**IN THE UNITED STATES DISTRICT COURT
FOR THE NORTHERN DISTRICT OF ILLINOIS,
WESTERN DIVISION**

AFFIDAVIT OF KONRAD J. BANASZAK, PH.D.

**Re: Response to IEPA Comments, February 10, 2016
Remediation Objectives Report
Consent Order No. 04 CH 28
GE facility, 709 West Wall St., Morrison, IL**

**Subject: GE Morrison Facility – Response IEPA Comments dated February 10, 2016
Remediation Objectives Report
Consent Order No. 04 CH 28
709 West Wall Street, Morrison, Illinois**

Figure 2
 Conceptual Site Model
 GE Morrison Facility
 709 West Wall Street
 Morrison, Illinois

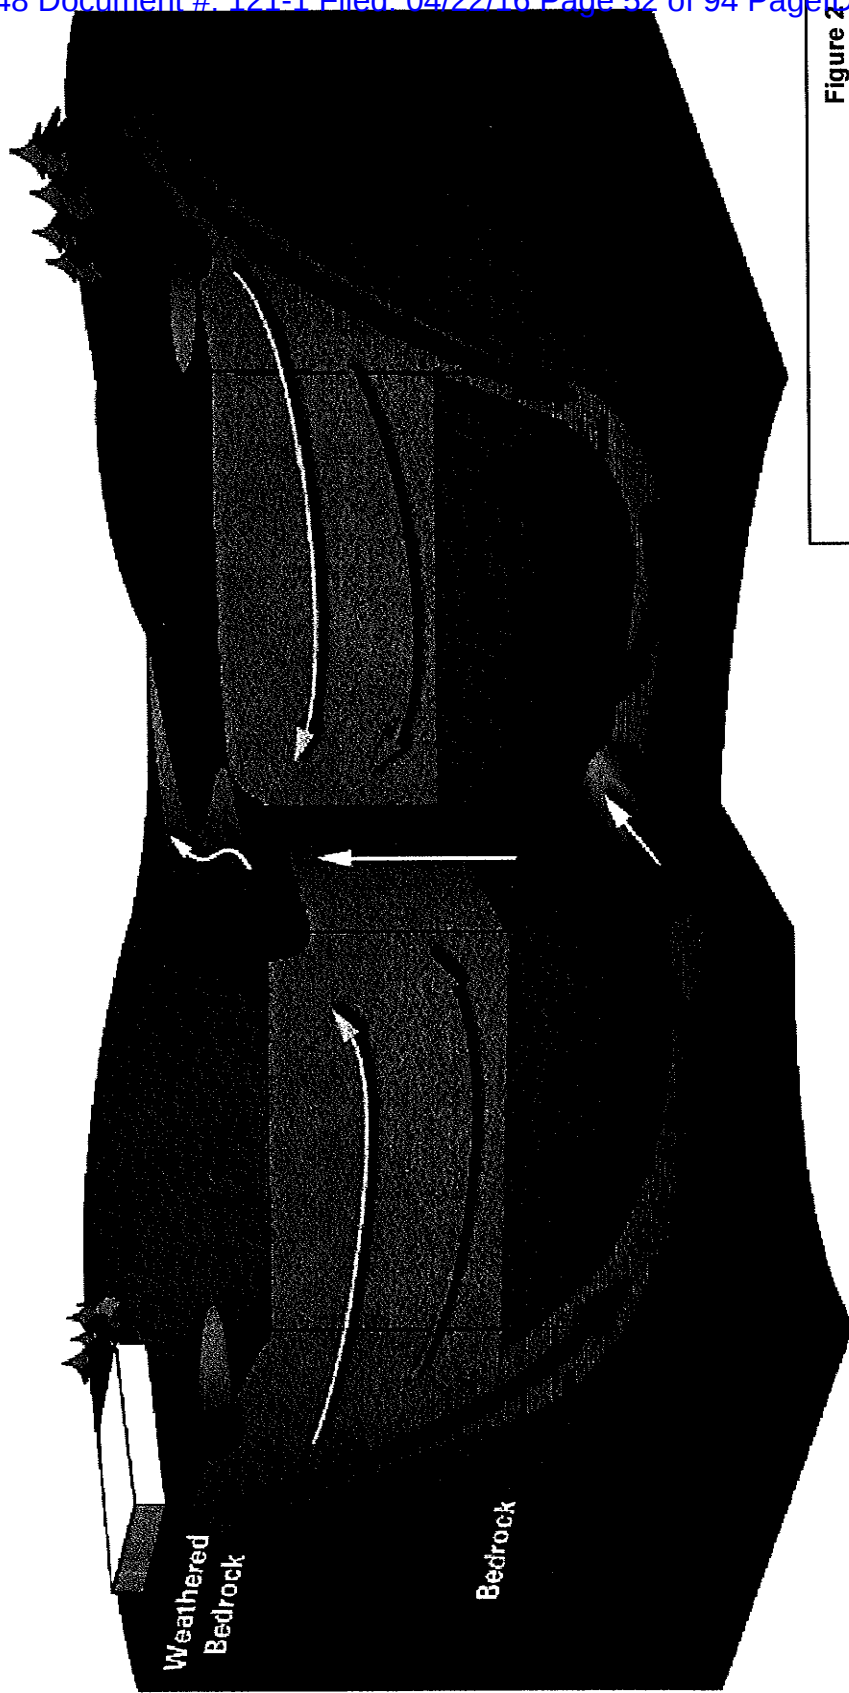
Figure 2 is a graphic of the CSM, drawn to provide a qualitative representation of the surface and groundwater flow and interaction in the Study Area. The following observations are made.

- The potentiometric pressures are equal and opposite from the north and south side of the creek in the bedrock interface zone, and so the blue cylinder on Figure 2 represents a zone of essential zero gradient in the north/south direction.

- The discharge volume to the creek from the hydrostratigraphic units is sufficient to make Rock Creek predominantly a gaining stream.
- Water level measurements at MW7-LS and MW8-LS also document the existence of a small horizontal gradient oriented west to east at the bedrock interface zone, along the axis of the creek, shown by the white arrow on top of the blue cylinder in **Figure 2**.
